SPITFIRE ENTERPRISES LTD
LAND AT HIGH POST, NEAR SALISBURY
TECHNICAL NOTE 1 – RESPONSE TO LHA COMMENTS
20TH JULY 2026

PROPOSED DEVELOPMENT
LISBURY, HIGHPOST
PROJECT SPITFIRE

ORTH FIELD SITE ACCESS PROPOSED ROUNDABOUT DESIGN PARAMETERS

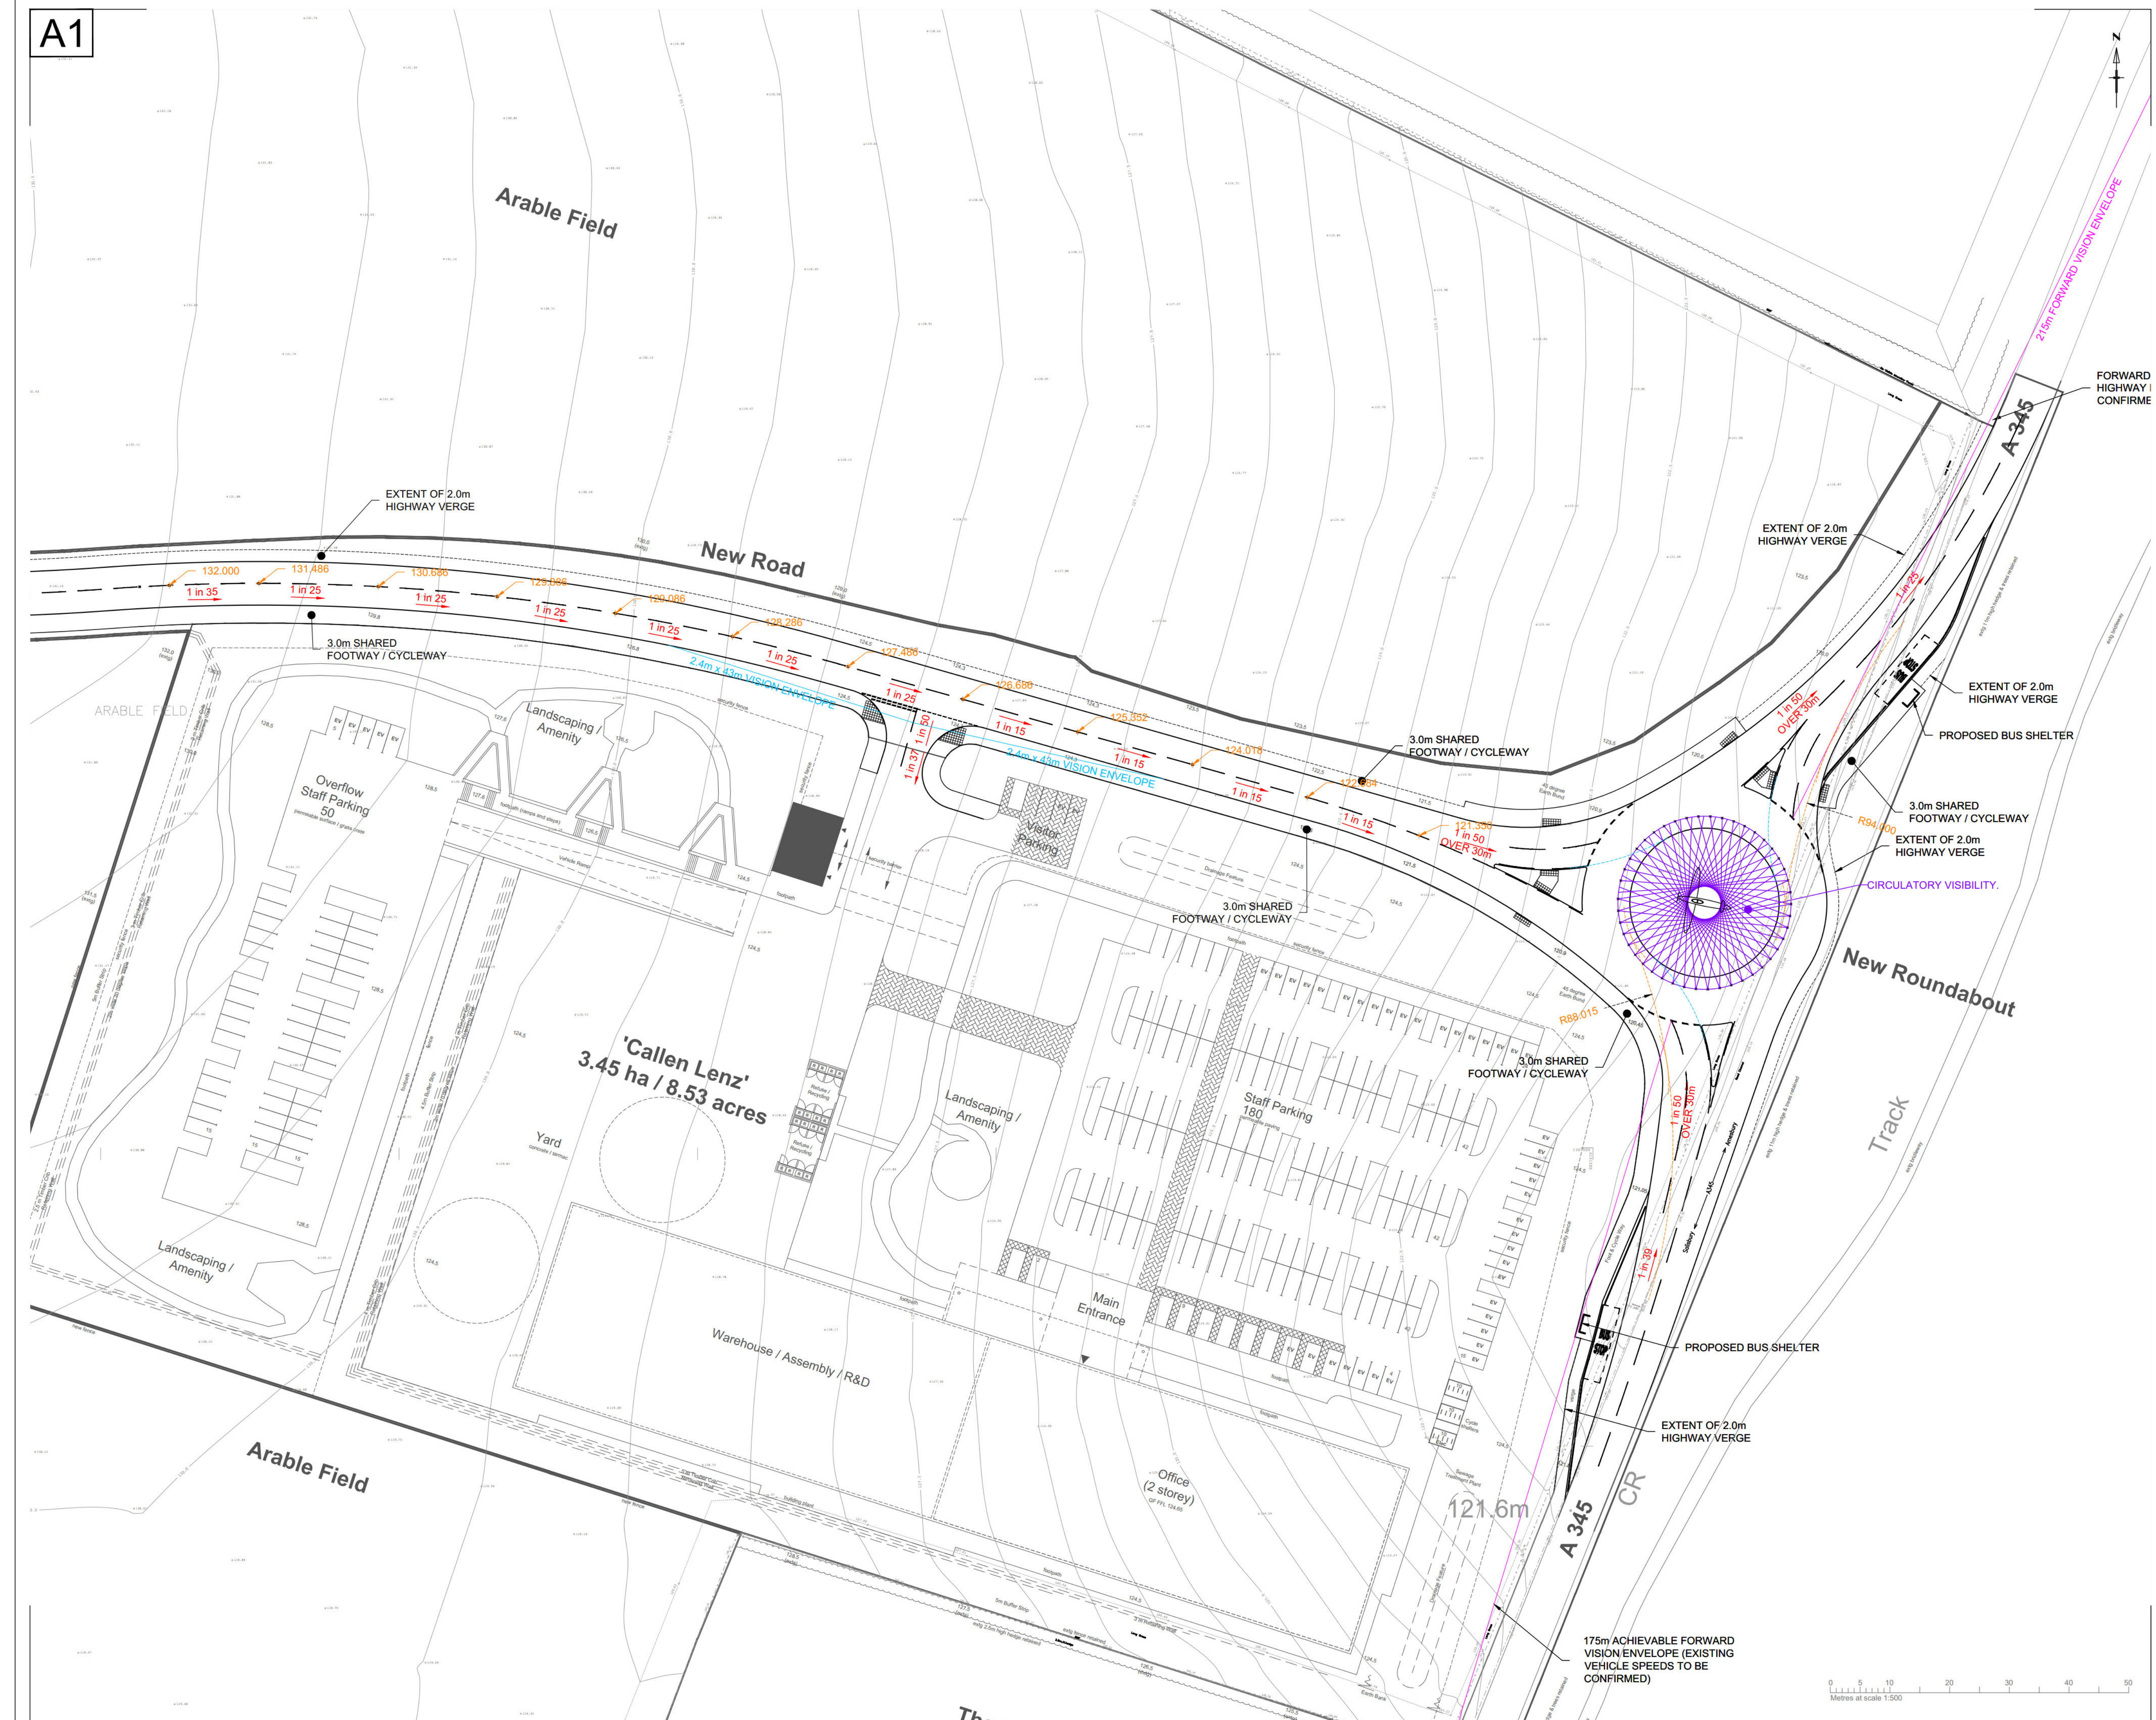
"3. Full planning permission is sought for the roundabout, but there is no detailed dimension plan showing all parameters required by CD116 Geometric Design of Roundabouts. This is essential."

Drg: 21106 - SK20260616.1 Rev -

- 2.3 After due and careful consideration the audit team have been unable to identify any areas of concern in terms of road safety associated with the information provided on this drawing for this stage of audit.

- 2.4 A drawing showing the design parameters and dimensions of the proposed roundabout junction is provided at Appendix 1 of this Technical Note.
